#### AMENDMENTS TO THE DRAWINGS

Jong-Joo LEE and Dong-Ho LEE  
 MULTI-CHIP BALL GRID ARRAY PACKAGE  
 Attorney Docket No. 9903-080/Application No. 10/828,792

## Annotated Sheet Showing Changes

FIG. 2

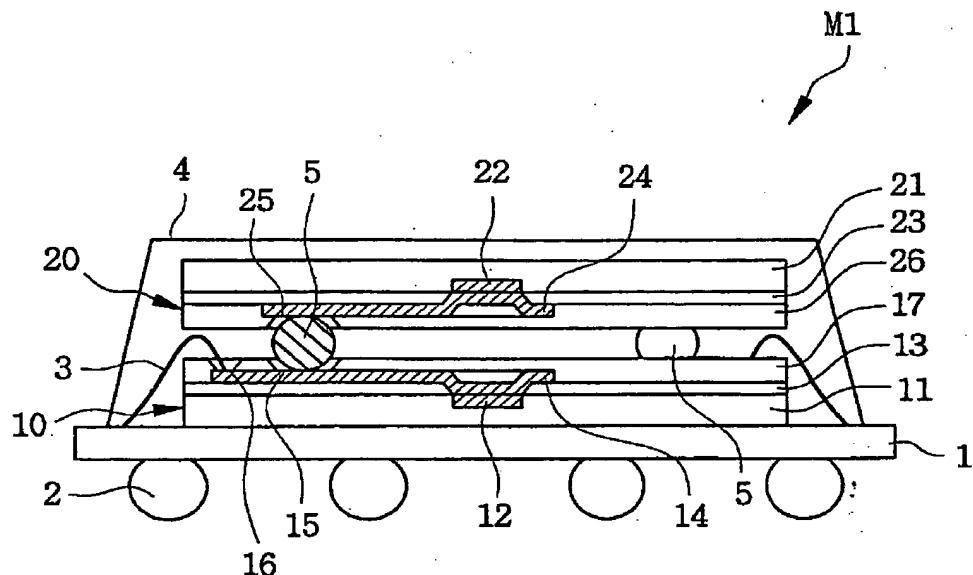
FIG. 2 is amended to include reference number 60 identifying the capacitor provided by the first and second electrode plates 37 and 46. An annotated sheet showing changes and replacement sheet are included in the Appendix following page 11 of this paper.

In a telephonic interview between the Applicant and the Examiner, conducted on August 31, 2005, the Examiner clarified that rejection was due to the capacitor not being specifically identified within any of the drawings. In response to the Applicant's question on how to overcome this rejection, the Examiner agreed that a separate reference number could be added to FIG. 2 to identify the capacitor formed by electrodes 37 and 46. FIG. 2 is amended to identify the capacitor as reference number 60 and a replacement sheet with the amended figure is included and can be found in the Appendix following page 11.
